**ADDENDUM #2**  
**PAH RAH PARK PLAYGROUND SURFACE IMPROVEMENTS**  
**BID# 19/20-010 PWP# WA-2020-075**  
**BIDS DUE NO LATER THAN: 1:45 P.M. ON DECEMBER 5, 2019**  
**PUBLIC BID OPENING: 2:00 PM ON DECEMBER 5, 2019**

**B) Updated Tile Detail**

# TILE OVER AGGREGATE CONTAINED BY CURB

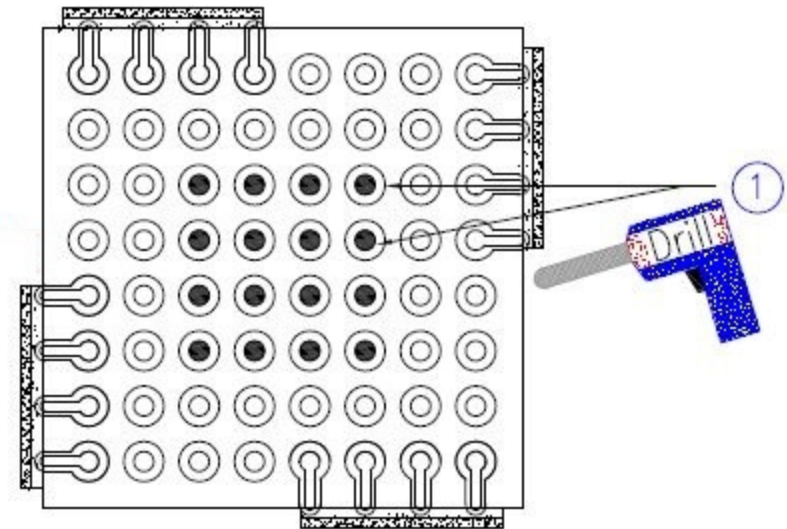
- a.** Attached are updated tile installation details for new tile installed. Underlayment liner to be installed would be obtained from the tile manufacturer. Contractor to install Type II aggregate base as needed and minimum 1” fine as shown on the detail to match finish grade. Cost associated with base work should be included in Bid Item No. 6. Compact Existing Base/New Base & Fabric. Cost associated with creating holes for perforated drainage should be included in Bid Item No. 7 Provide/Install Rubber Tiles.

1. Consult with a local Civil Engineer to find out what drainage system is best for your application.
2. Ensure subsoil drains towards drainage system.
3. Review Most Recent Installation Manual and Sub Surface Guide
4. Contractor to install manufacturer recommended rubber sheetting and install per manufacturer spec.
